# CDM Validation Report

CDM Validation

Busan Metro Line 1 Dadae

324167/P32040.33

**Figure 6: Baseline and Project Emissions**

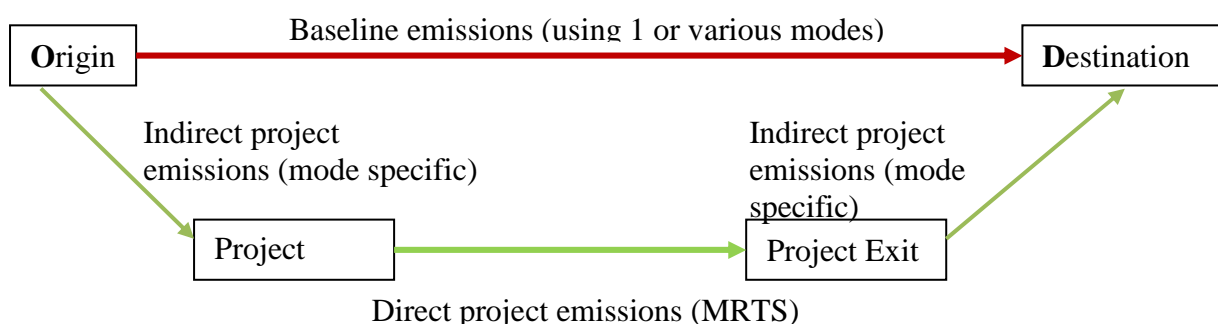
Figure 6 provides an overview of baseline and project emissions, latter being differentiated in indirect and direct project emissions.
